OVERLOOK PLACE SUBDIVISION, PHASE I & PHASE II

APPLICATION NUMBER 14 DATE January 19, 2006

DETAIL SITE PLAN

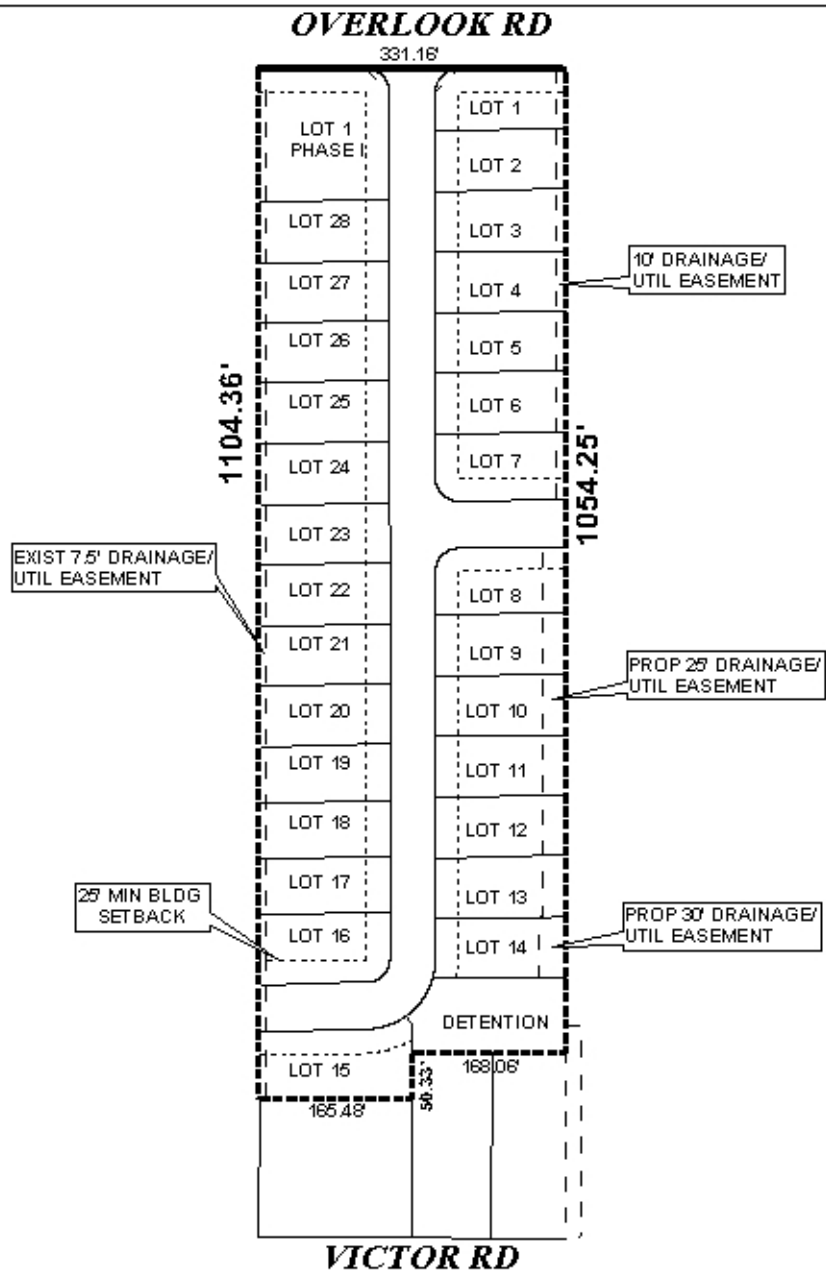
As shown on the Detail Site Plan, two proposed new streets stub into adjacent properties located at the western and eastern property lines of the site.

A detention area is shown on the plat, thus the placement of a note on the final plat stating that maintenance of the detention area shall be the responsibility of the property owners should be required.

The plat meets the minimum requirements of the Subdivision Regulations and is recommended for Tentative Approval subject to the following conditions: 1) the placement of a note on the final plat stating that Lot 1 is denied direct access to Overlook Road; 2) construction and dedication of new roads to meet City of Mobile standards; 3) all detention areas be indicated on the final plat with a note stating that the maintenance thereof is the responsibility of the property owners association; and 4) full compliance with Urban Forestry comments (*Mobile Tree Commission Permit is required before removing trees from existing city right of way*).
